# 9323/9360 software and hardware upgrade for morse code

This Service Bulletin affects the users of 9323/9360 transceivers with Option M and software versions 4.34 or earlier, who need to send morse code at speeds of up to 68 words per minute. It applies to transceivers fitted with Microprocessor and Audio PCB, part number 07-01536-11 or earlier. The location of the PCB part number is shown in Figure 1.

Figure 1: Hardware modification to the Microprocessor and Audio PCB (07-01536-11)

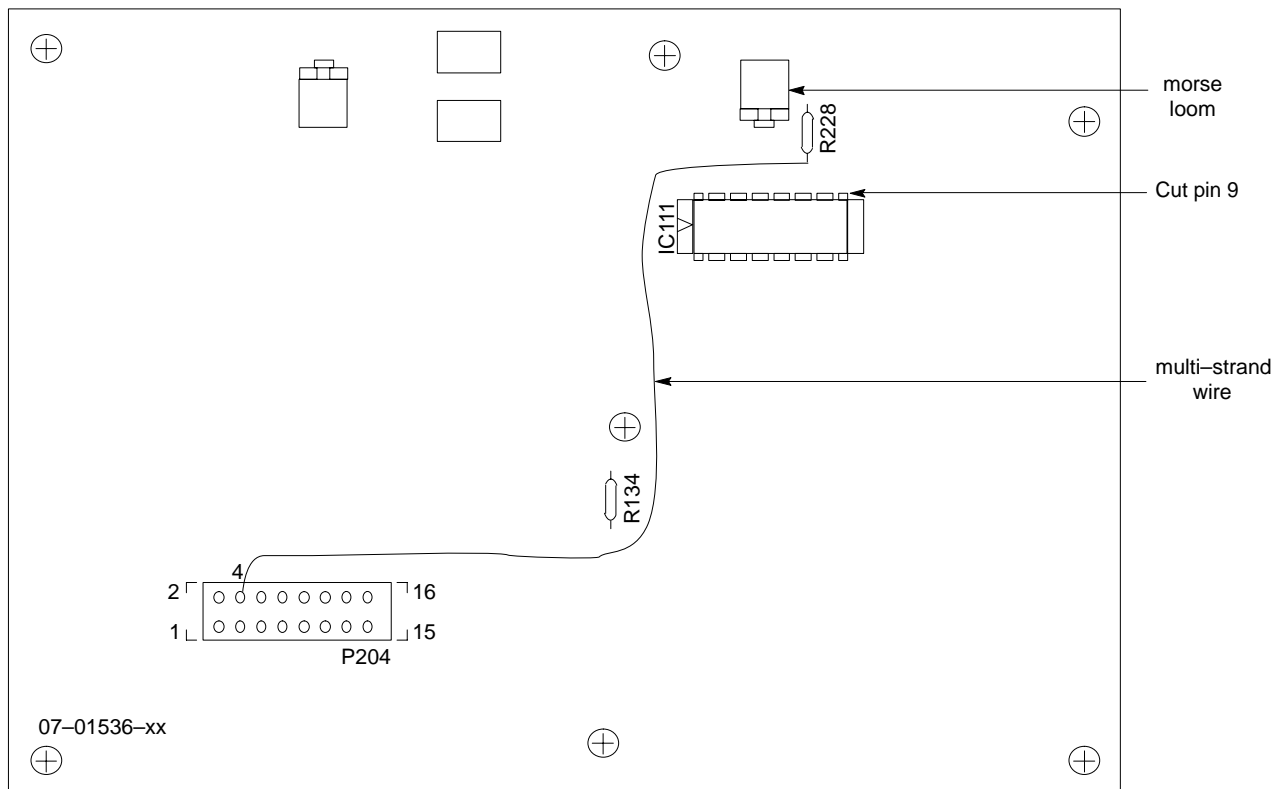
The switching speed of the transceiver is too slow causing high speed morse transmissions to sound irregular.

- Switch the power off.
- From the component side of the Microprocessor and Audio PCB (assembly part number 08-04966, PCB part number 07-01536-11), cut pin 9 of IC111 using side cutters (see Figure 1).

Ensure there is no connection between pin 9 of IC111 and R228 through visual examination or using an ohm-meter.

- Route the multi-strand wire (part number 66-02072-005) from R228 to pin 4 of P204 (see Figure 1).
